Part 21 (PAR)

PART 21 - SERIES 24 CSR RELAYS WITH OVERSIZED CAM DRIVE COMPONENTS

Subject: 10 CFR Part21 Reporting of Defects and Noncompliance
Electroswitch Report # 10CFR21-032513 Rev. 0

Electroswitch	NON CONFORMANCE REPORT	Rev: J	Document no: NONCON-1 CAR #13-002
---------------	-------------------------------	-----------	---

Drive cam:
.4385 dimension
referenced in table
below is the OD

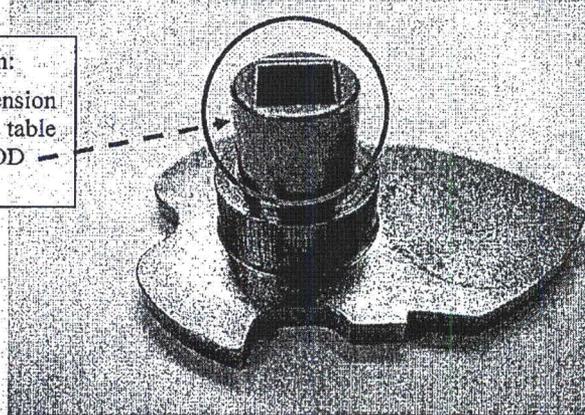
1. Immediate disposition once switch was returned on RA #4850:
 - a. Initial evaluation: Performed bench test to see if problem could be replicated. Results: Switches did initially close when relay was de-energized, open when energized and close when de-energized. Because the results did not replicate failure mode at customer, engineering was brought into evaluation.
 - b. Engineering evaluation: Performed bench test again. Results: Failure mode could be replicated when switch was kept energized for a short period of time (10 seconds).
 - c. Based upon the results, Engineering had recommended the drive cam portion of the drive assembly be checked for movement. Refer to picture #1 and #2 on page 2 of report.

- d. Measured the three components which make up the drive cam assembly.

Component	Dimension specification	Actual dimension
Drive cam (after plating)	.4385 +.0000/-.0005	.4388 .4392
Drive cam (before plating)	.4380 +.0000/-.0005	.4381 .4385
Nylon bushing	.4385 +.001/-.000	.4390
Mounting plate	.5000 +.0000/-.0005	.5000

The root cause has been determined to be oversized OD dimension on the drive cam. This tight fit in the nylon bushing and mounting plate did not allow the drive cam to close when de-energized.

It was found, during the evaluation, that the drive cam drawing was not clear with respect to the OD dimension being such before or after plating.

1. Engineering will be revising the drive cam drawing (see table below):
 - a. The OD specification on the drive cam will be revised.
 - b. The plating specification on the drive cam will be revised.
 - i. The plating specification changed from .0004 max to .0003 max.

Component	Original dimension specification	Revised dimension specification
Drive cam (after plating)	.4385 +.0000/-.0005	.4386 max
Drive cam (before plating)	.4380 +.0000/-.0005	.4380 +.0000/-.0002
Nylon bushing	.4385 +.001/-.000	Same
Mounting plate	.5000 +.0000/-.0005	Same

- c. With these changes, the stack up tolerance, which may have caused a restriction in movement, will be eliminated.
2. Test procedure will be revised to keep switch energized for 10 seconds
